RATING FACTOR 3.A.: CONTROL BOARD OPERATIONS, LOCATE &
MANIPULATE

1. Examiner comment on 303 form p. 18 of 32, related to Scenario 7, Event 1

Op-Test No.: 2012-301

Scenario No.: 7

Scenario #7 Group #1

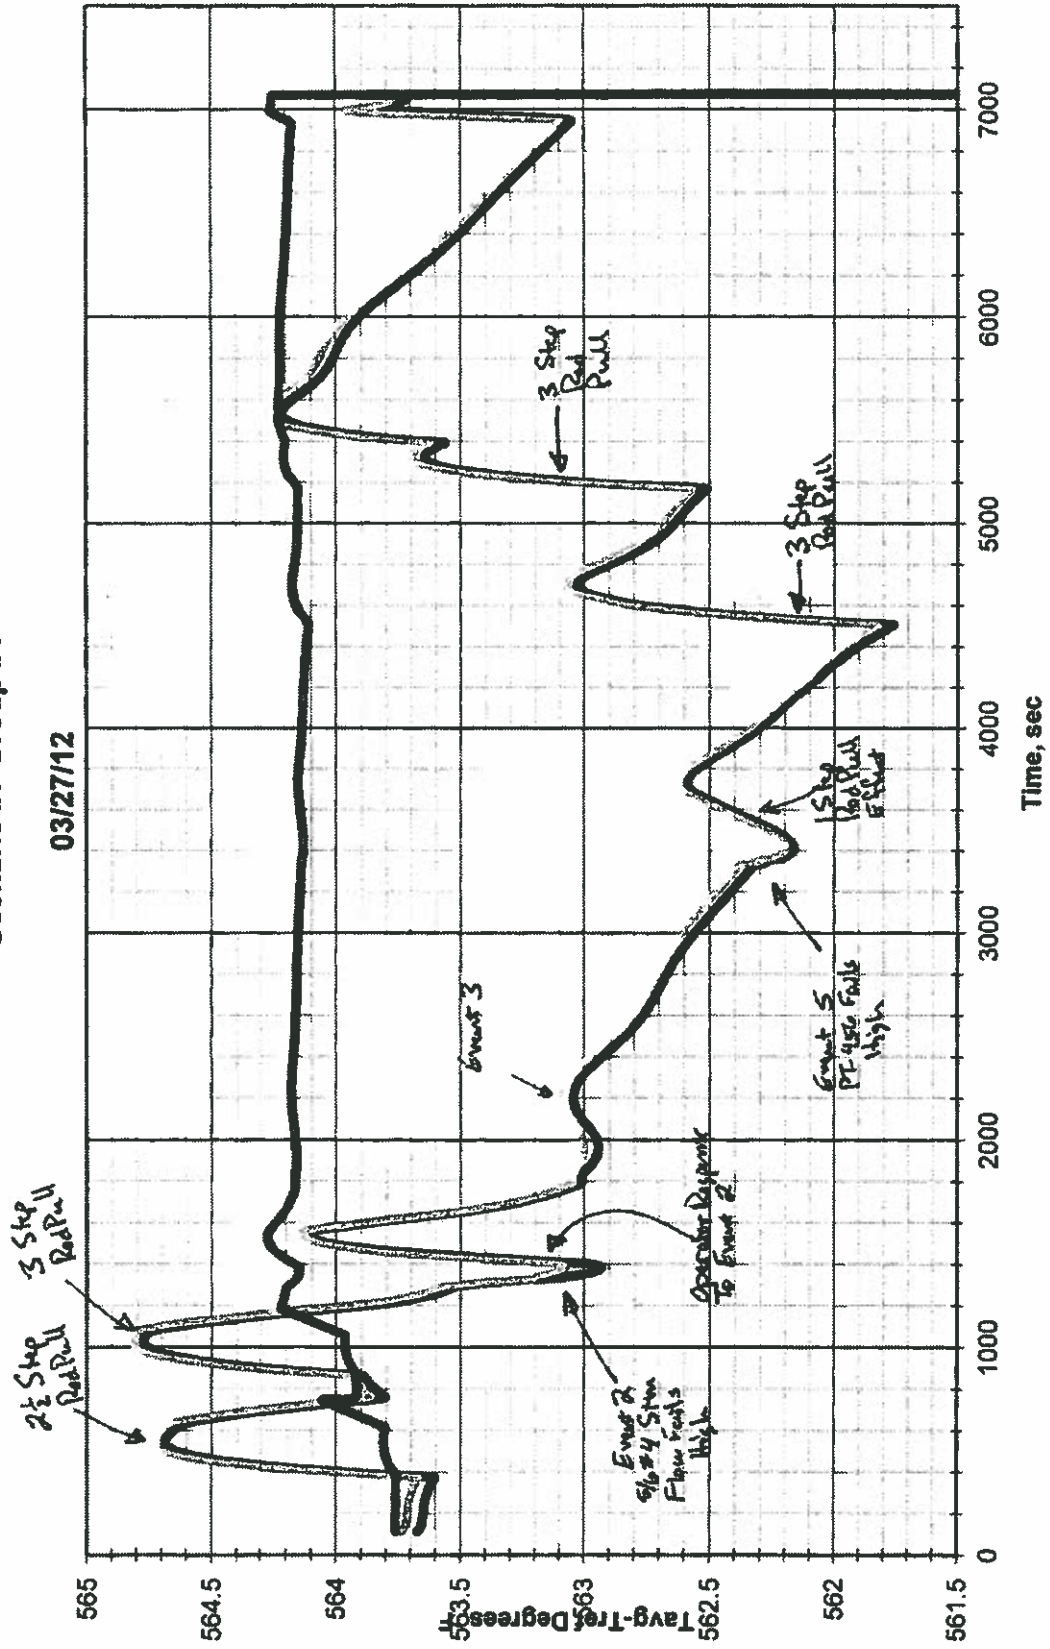
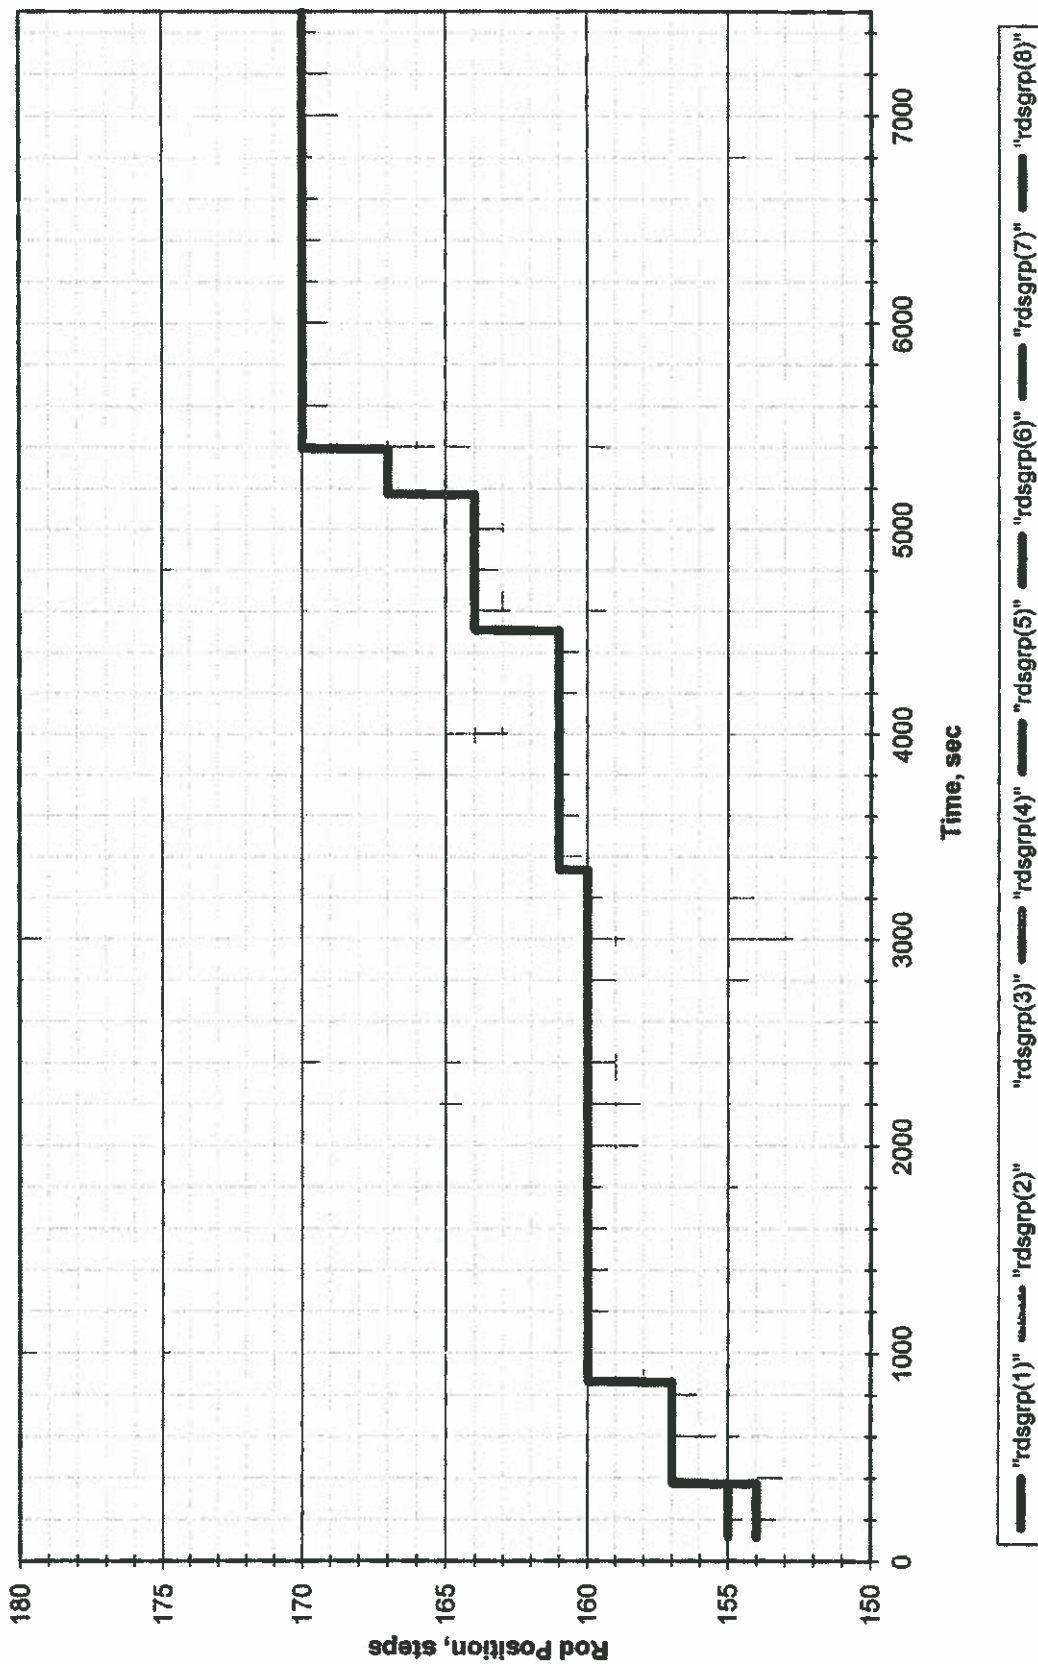
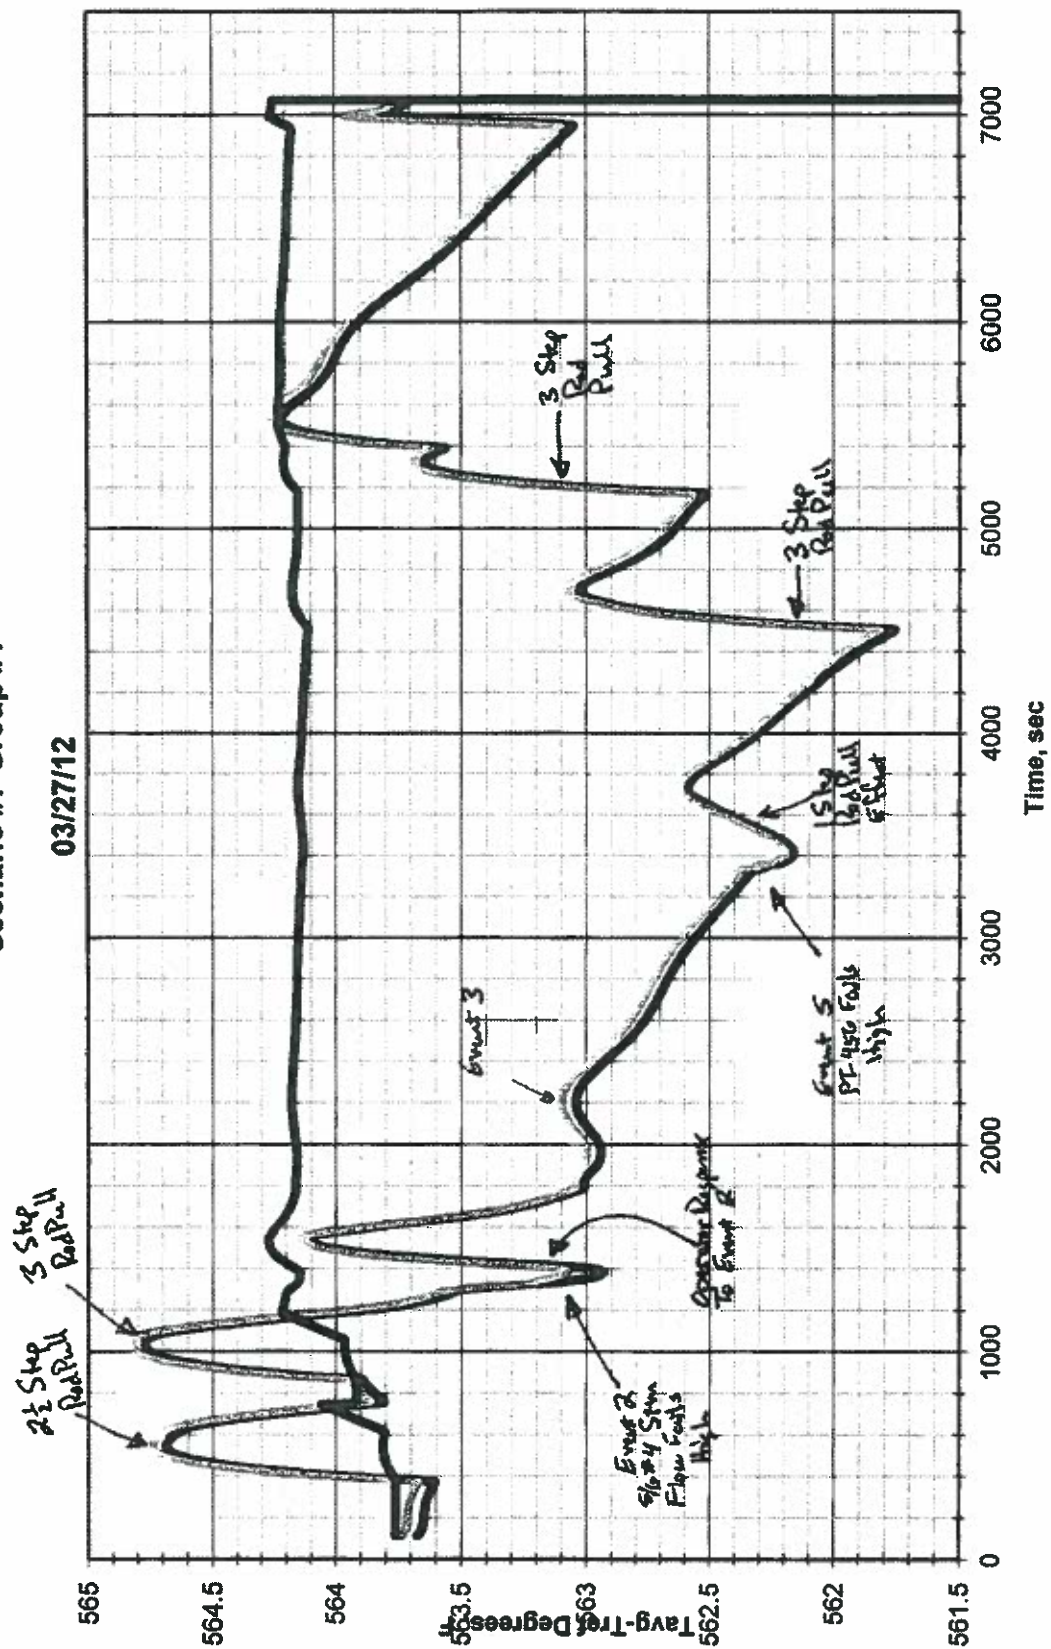
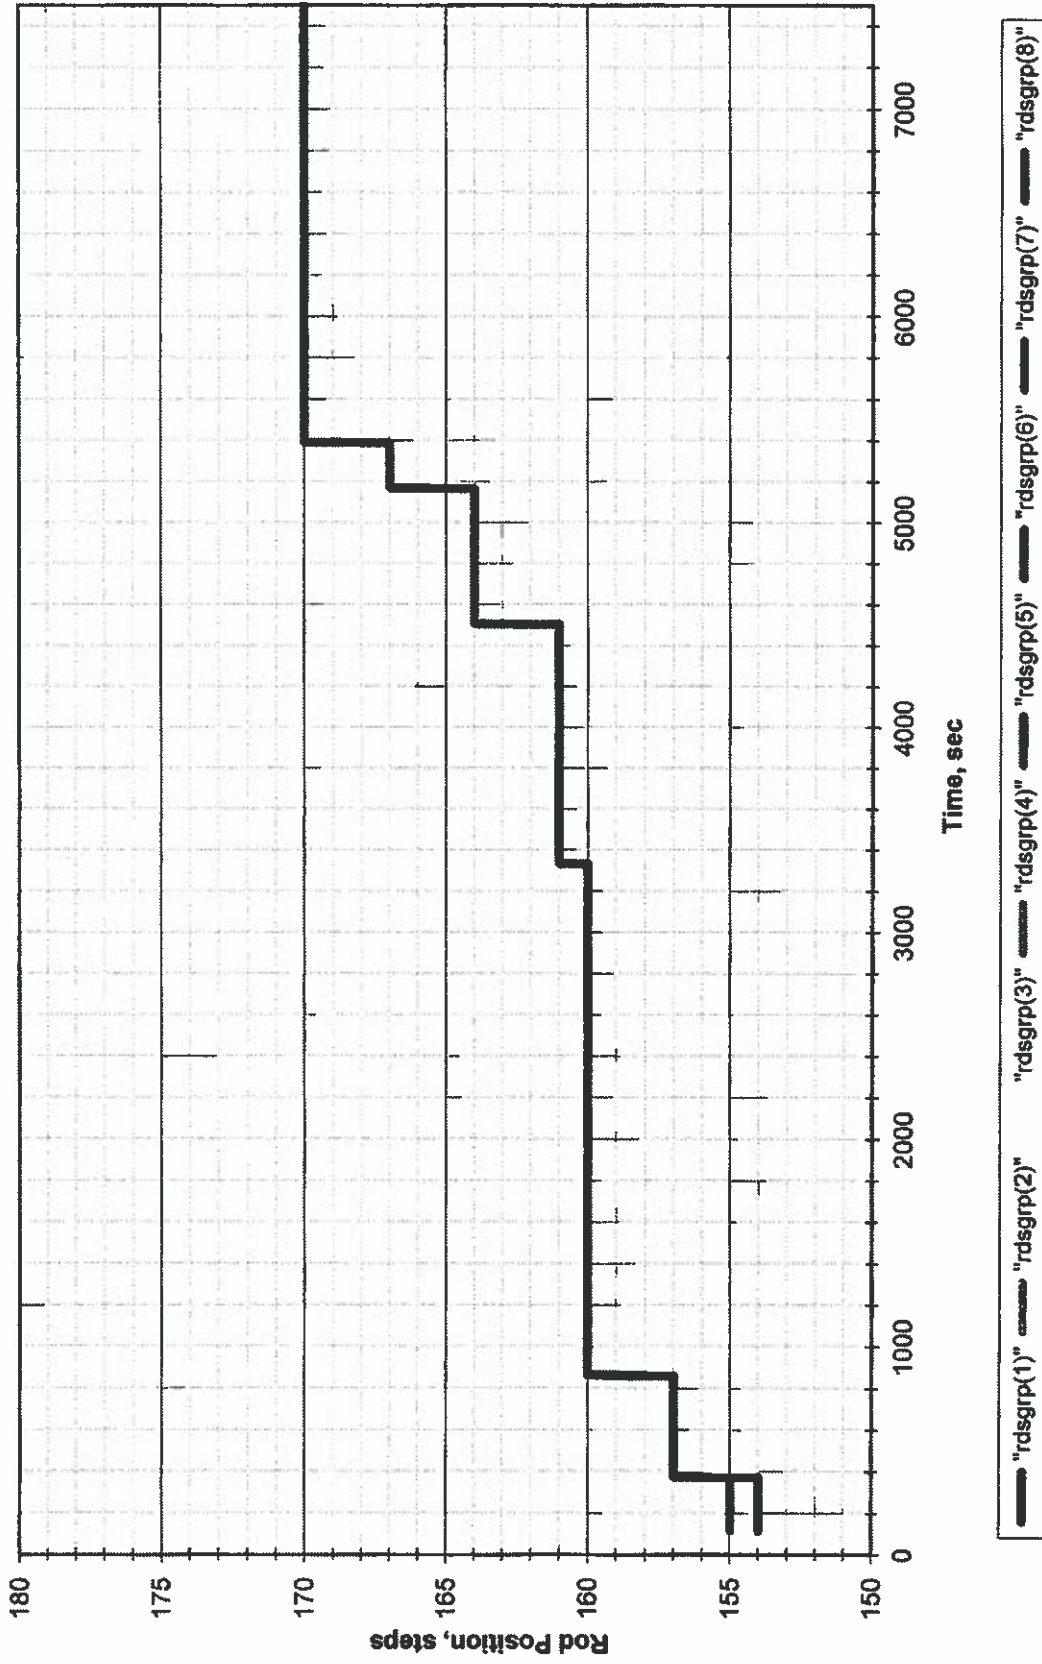
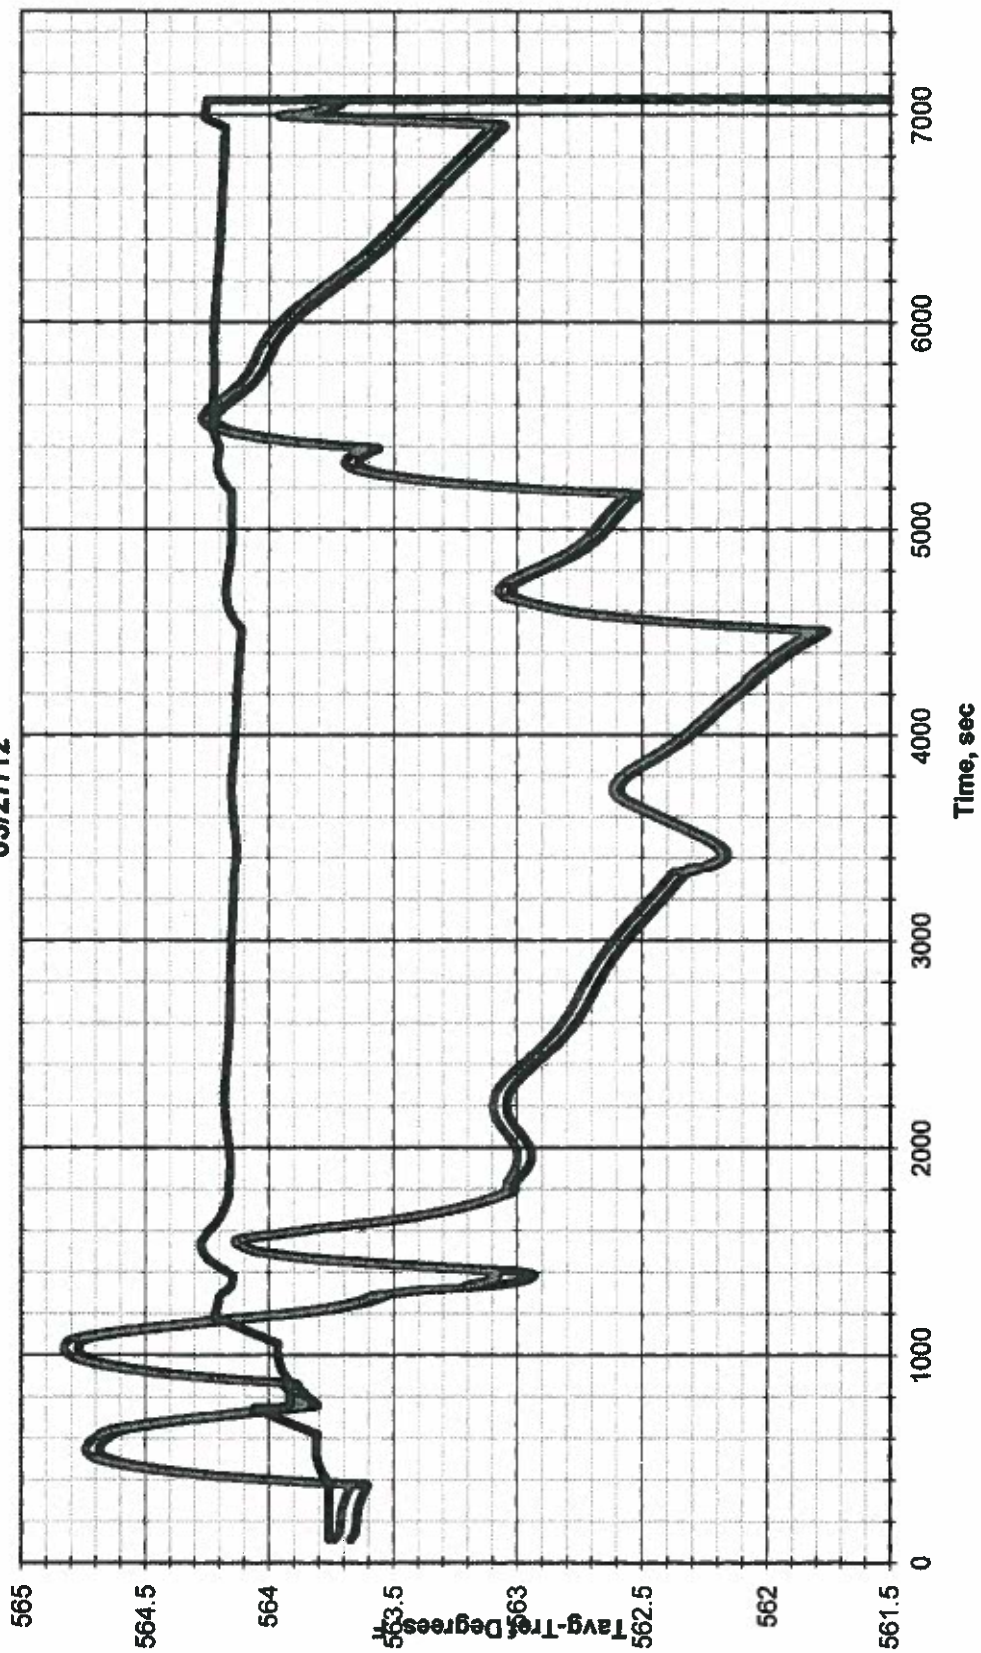
- At approximately time 08:18 Carla began what was intended as a 3-step outward rod pull. Rods were only moved by 1 step due to initiating event 5.
- At time 08:18:02 event 5 was initiated, where pressurizer pressure channel PI-456 failed high.
- At time 08:18:17, Carla released the in-hold-out switch and informed [REDACTED] of the pressurizer pressure malfunction.
- At time 08:37:??, Carla moved rods out 3 steps. Just before the rod move, Tave-to-Tref deviation was -2.297 °F. Tave-to-Tref was outside the established control band for approximately 4.8 minutes.

During post-scenario follow-up questions, the examiner asked Carla "what was your temperature control band?" Carla answered that it was plus or minus 2 degrees. The examiner asked Carla what the maximum Tave-to-Tref difference had been during the scenario. Carla responded that the maximum difference had been 2.3 degrees F.

The examiner determined that the root cause deficiency was a result of poor control board operations. NUREG 1021, Appendix D 2.c. states for the competency *Operate the Control Boards* that "This competency involves the ability to *locate* and *manipulate* controls to attain a desired plant and system response or condition." ES-303 form ES-303-4 further specifies that the 3.a. rating factor determines if "...the applicant LOCATE AND MANIPULATE CONTROLS in an accurate and timely manner." For this event, Carla, as a control board operator, failed to manipulate the controls in a timely fashion to obtain the desired system response of maintaining Tave-to-Tref deviation between the ordered 2 degree band. Based on post-scenario follow-up questions, there was no deficiency in understanding; furthermore, there was no element of taking manual control of automatic functions because rods were in manual from the initiation of the scenario. Vogtle does not operate with automatic rod withdrawal capabilities, only automatic rod insertion.

There is a further element of poor communications during this event. There is no record from any NRC examiner of any communications during an approximate 40 minute period of time where Carla notified the SRO of the Tave-to-Tref value and trend. This is a clear example of a deficiency in rating factor 4.b., "Did the applicant keep crew members ... informed of plant status?"
